工程指示 / 要求簡箋(E.I.)

工程指示編號：EI / 3181 / 21

工程編號：J - 852

工程項目：幕牆 地盤用玻璃 B.M. 大貨 (T1-T3) (1-23/F) (468 件)

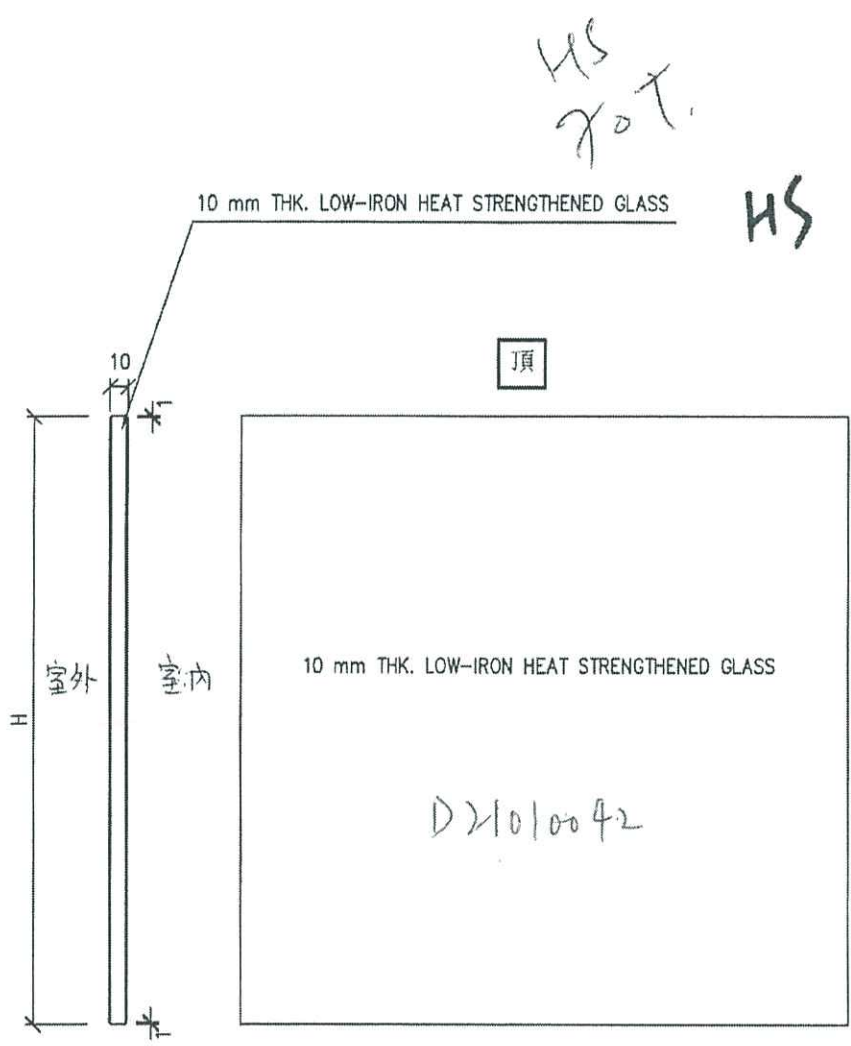
B 版：放行死牆玻璃訂購，玻璃已批 D21010042 款(見附相)
